SUBJECT: Calvert Cliffs Nuclear Power Plant
Unit Nos. 1 & 2; Docket Nos. 50-317 & 50-318
Response to Requests for Additional Information for the Emergency Core
Cooling System Surveillance Requirement Change

Attachment: (1): Response to Request for Additional Information
Enclosure: (1) Strainer Layout and Strainer Module Anchor System

RESPONSE TO REQUEST FOR ADDITIONAL INFORMATION

UNIT 2
CCI STRAINER LAYOUT
REDLINE DRAWING

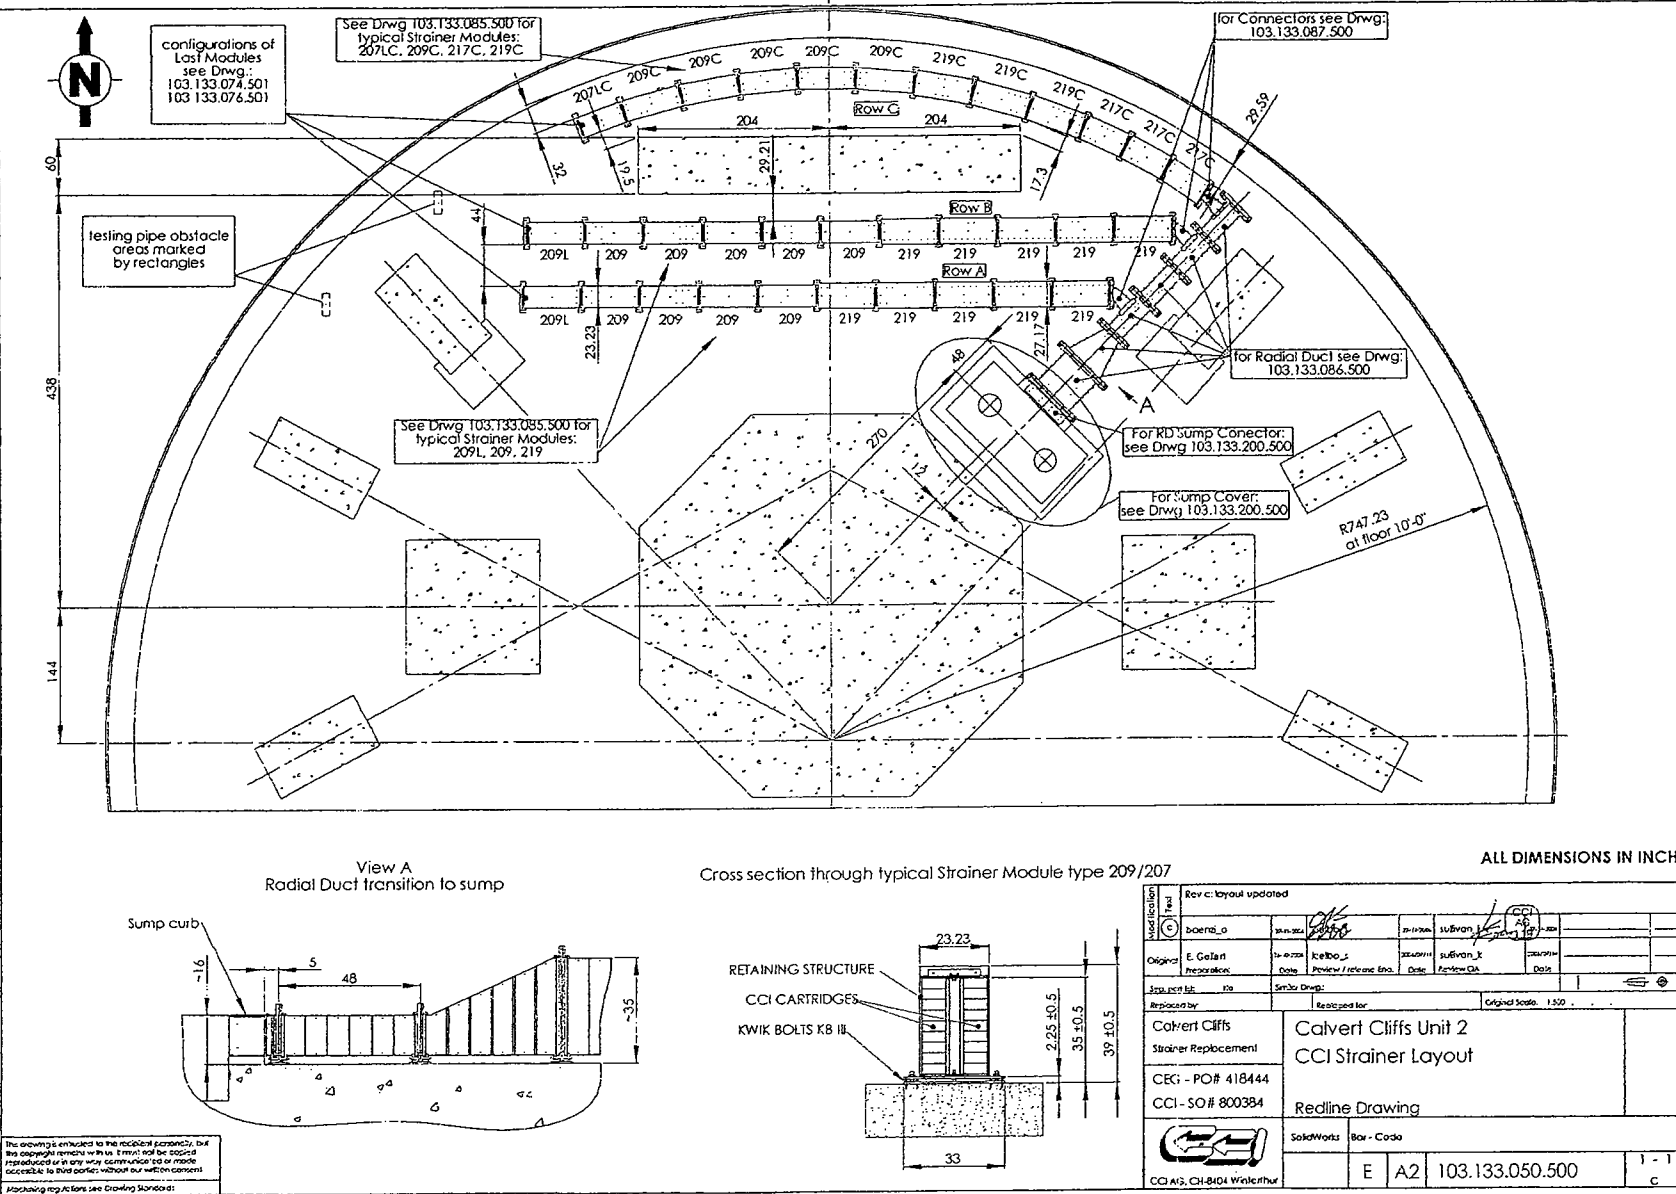
Provide Information showing the layout of the new strainer arrangement and its support system.

See Enclosure (1), which provides a drawing showing the strainer layout and a drawing of the strainer module anchor system.
